DESCRIPTIVE REPORT

Descriptive Report to Accompany Hydrographic Survey H11571

Project OPR-O119-FA-07
Ernest Sound and Eastern Passage, Alaska

TITLE: Approval of Hydrographic Survey H11571,
OPR-O119-FA

Figure 3: Cliff shown at FAIRWEATHER depth range resolutions

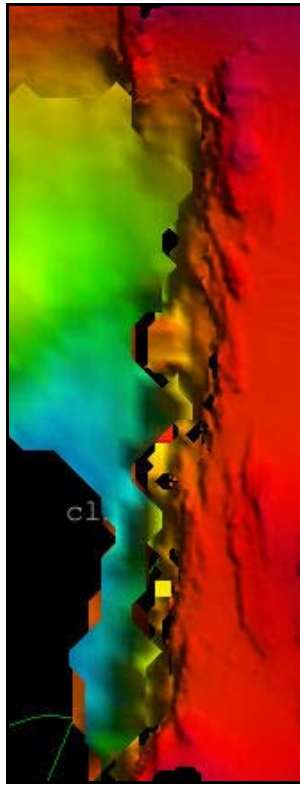
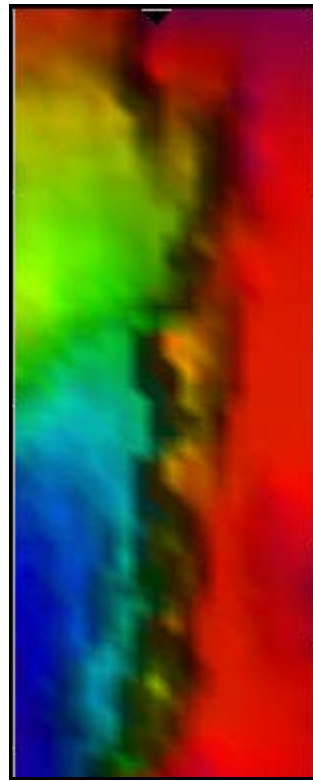
Similar to surveys H11570 and H11572, H11571 has numerous areas of extremely steep underwater cliffs. Frequently dropping over 100 meters in an almost vertical line, the cliffs made it extremely difficult to display full multibeam coverage at all relevant depth resolution levels in CARIS HIPS. At the FAIRWEATHER filtered resolution levels (see Table 4), noticeable apparent data gaps (<3 nodes across) were present in the data (see Figure 3). However, when a blanket coarse resolution such as the 20m or

35m resolution is displayed, the gaps are not present (see *Figure 4*). The example in figures 3 and 4 is centered at position 56° 01.25'N, 132° 03.6'W in the East fieldsheet.⁵

⁵ During office evaluation of the survey, the fieldsheets were reconfigured with different grid resolutions and greater overlapping depth threshold that closed the gaps between finalized surfaces on steep slopes. See Survey Acceptance Review checklist and memo filed with the hydrographic records.

Figure 5: Roll and pitch artifacts from POS M/V in H11571_North fieldsheet

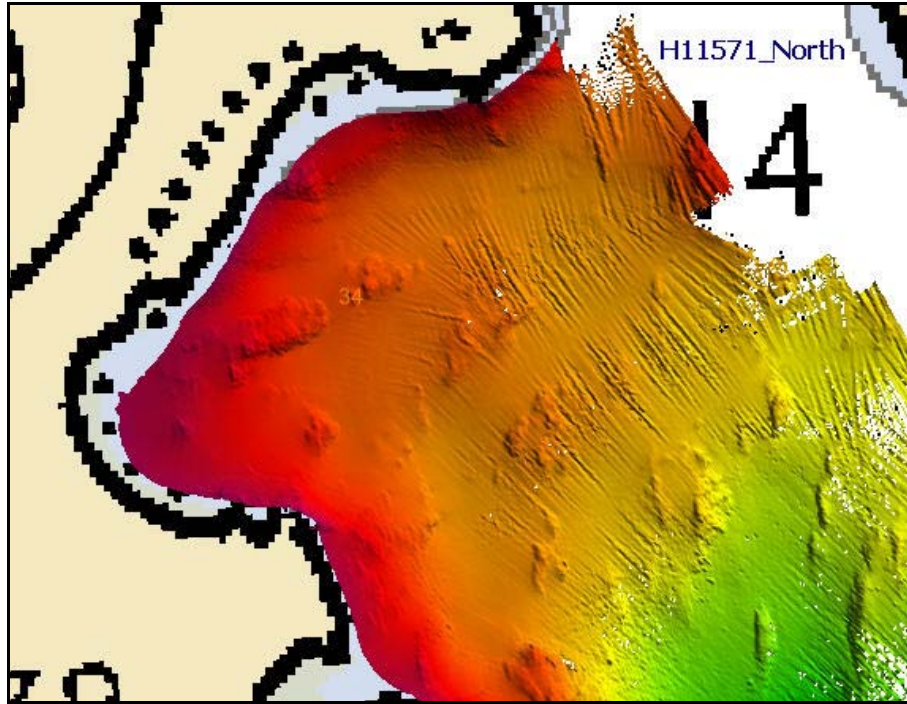
The POS M/V attitude data on launch 1018 was logged at 1 Hz as opposed to the usual 25 Hz during acquisition on H11571. As a result, roll and pitch artifacts appeared in some of the shallower areas in H11571. (See *Figure 5*) An email on this issue is located in the correspondence folder in Appendix V. The CUBE surfaces in the affected areas were inspected using CARIS subset mode, and the internal consistency and integrity of affected data were found to be within IHO standards.⁷

⁷ The Survey Acceptance Review states that not all data were within IHO Order 1 tolerance. Because the area was small with depths greater than 50m, the recommendation is to accept and chart the survey data. See Survey Acceptance Review checklist and memo filed with the hydrographic records.

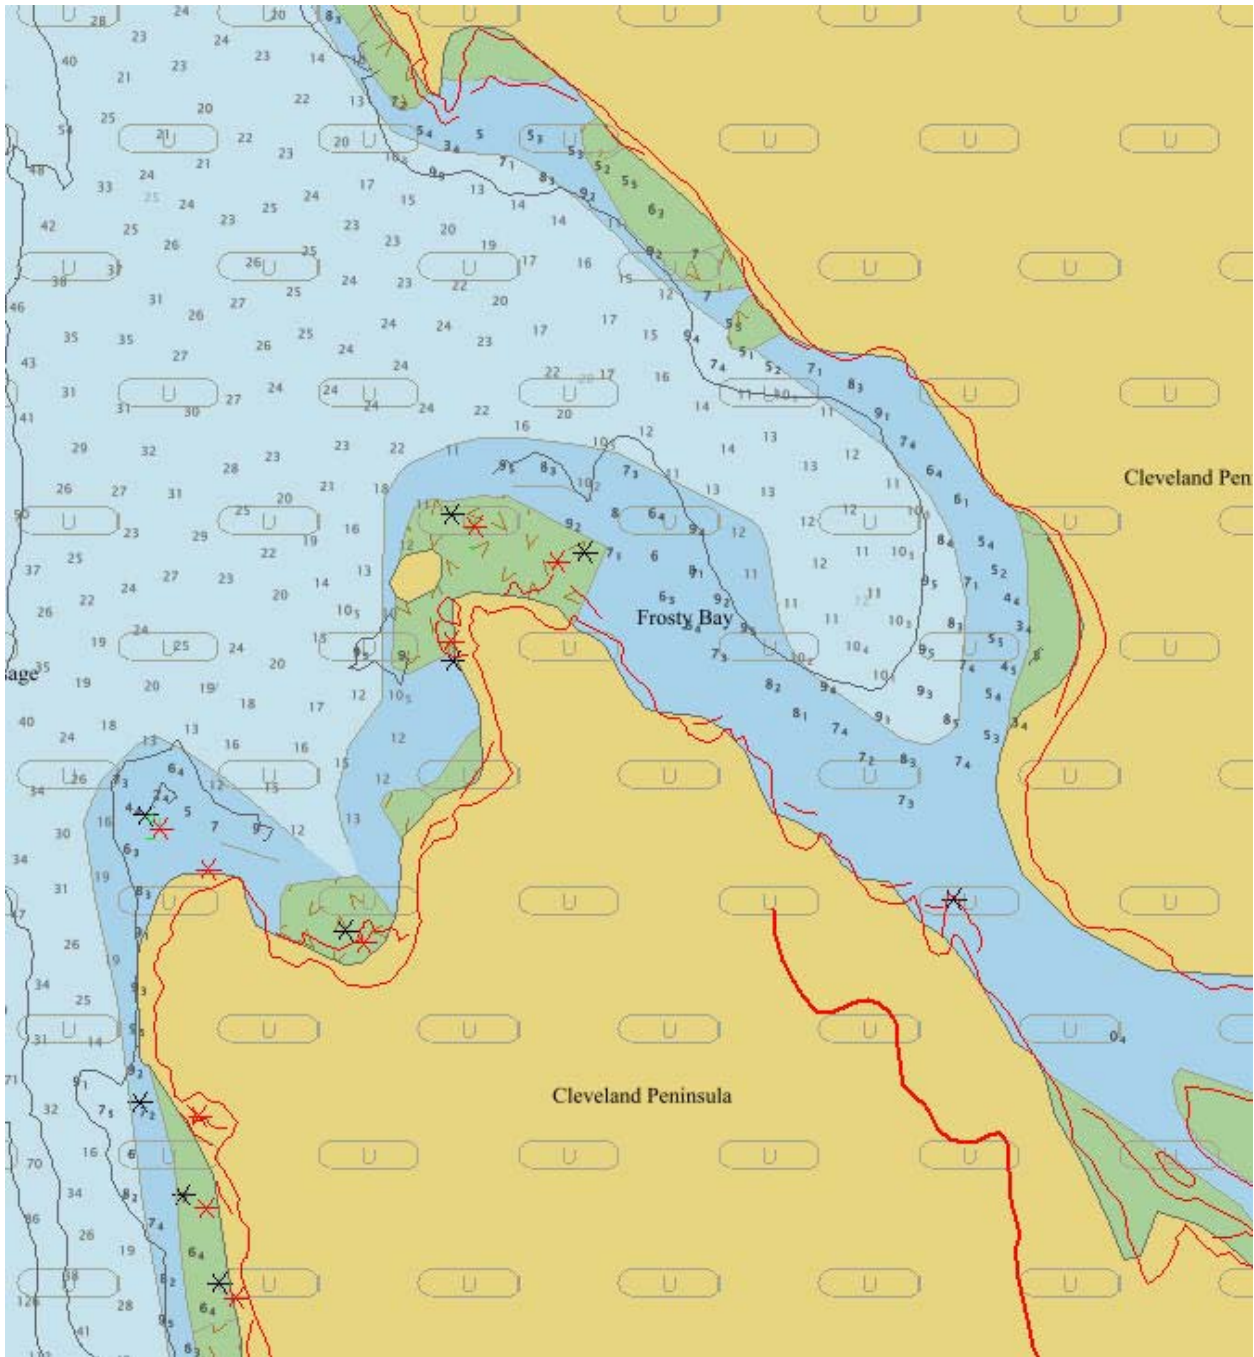
This is one of the areas in H11569 where the GC has not been applied to ENC US4AK3OM or chart 17385.

The GC (Composite Source) is in red. There are plenty of places where soundings/DEPARE overlap with ledges.

We looked at the GC application and realized that it was applied to the raster with a southeastern shift of about 0.33 mm. This error was reproduced on the ENC.

I recommend you compile the hydro in it's exact geographic position with an understanding that the GC horizontal accuracy is correct, but our ENC/Raster may not be horizontally accurate. It would not help us to apply the GC shoreline in the HCell. If you need more help describing the error so you can make a note of it, I'm happy to discuss it.
